**Re: Entegrus Powerlines Inc. (Entegrus Powerlines)  
2026 Cost of Service Rate Application  
Ontario Energy Board (OEB) File Number: EB-2025-0044**

**OEB Staff Interrogatories**  
**2026 Electricity Distribution Rates Application**  
**Entegrus Powerlines Inc. (Entegrus Powerlines)**  
**EB-2025-0044**  
**November 7, 2025**

Table 4-3: Station Transformer HI Algorithm

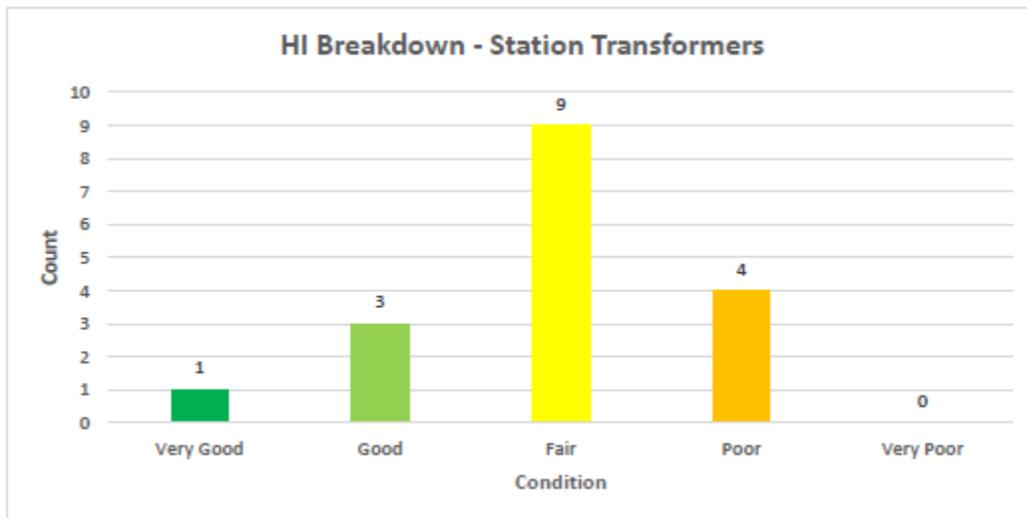
- (c) Please elaborate on the what does Entegrus Powerlines mean by “distribution stations are nearing end-of-life” in reference 3, considering that distribution station comprises on several assets such as station building, power transformers, circuit breakers, switches, etc.

- (d) Has Entegrus Powerlines performed risk analysis for each station for their entire stations fleet?
- (e) Was Health Indices for stations equipment taken into consideration in coming with the voltage conversion plan?

- (f) If service age was to be removed from asset condition assessment for power transformers, how would the Health Indices change for power transformers?
